PHILADELPHIA ELECTRIC COMPANY

Re: Docket Nos. 50-277
50-278

On November 5, 1979, a partial response was submitted to your October 5, 1979 request for additional information with respect to our August 27, 1979 application for amendment to Facility Operating License Nos. DPR-44 and DPR-56 for the Peach Bottom Atomic Power Station Unit Nos. 2 and 3. The proposed amendments involve the use of analog transmitter/trip unit systems for certain engineered safeguard sensors. The requests which we could not respond to previously concerning environmental information are restated below with the necessary information.

PEACH BOTTOM
ENVIRONMENTAL INFORMATION
GRAPH 1

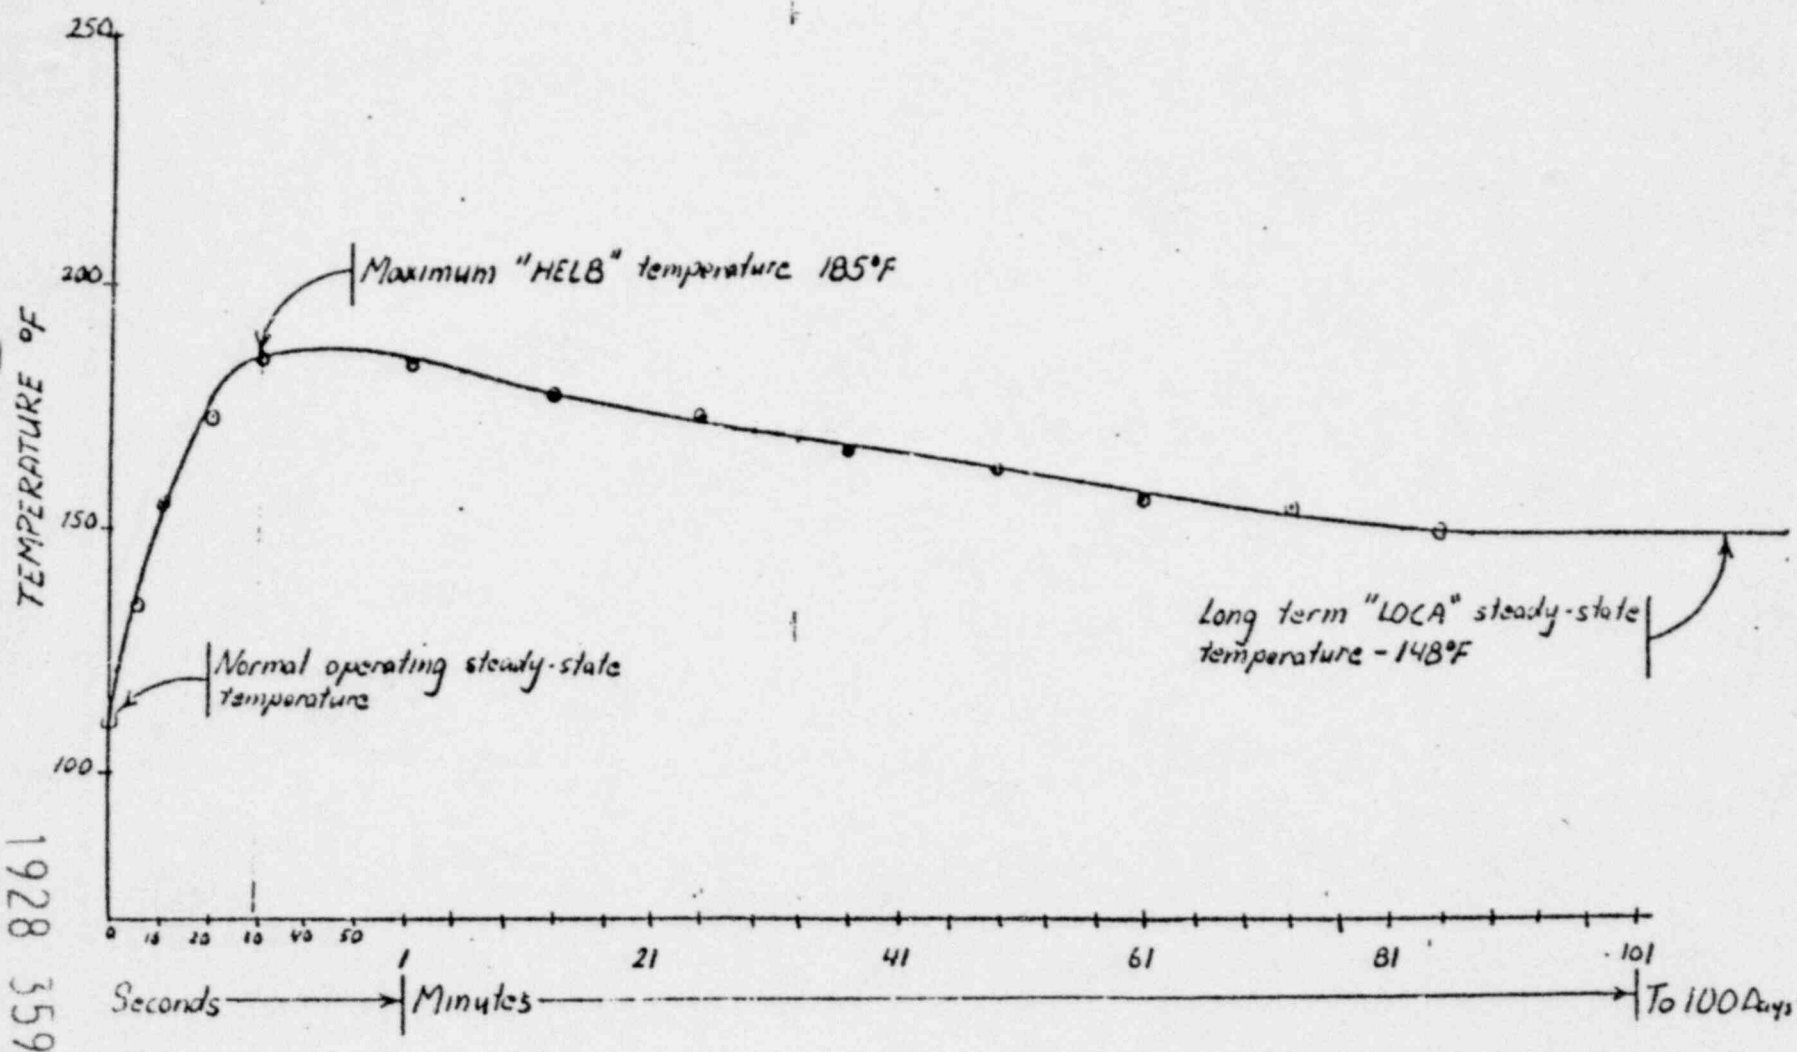
2. For each location, state the maximum and minimum abnormal environmental conditions that are expected

during normal, accident, and post-accident situations.
The information should include magnitude and duration.

The required information is supplied in Appendix A which includes Table 1 and Graphs 1 through 4.

TEMPERATURE VS. TIME CURVE FOR ROOM NO. 403
RESULTING FROM "HELB" AND "LOCA" FOR PBAPS
UNITS 2 AND 3 (OPERATING AREA EL. 165')
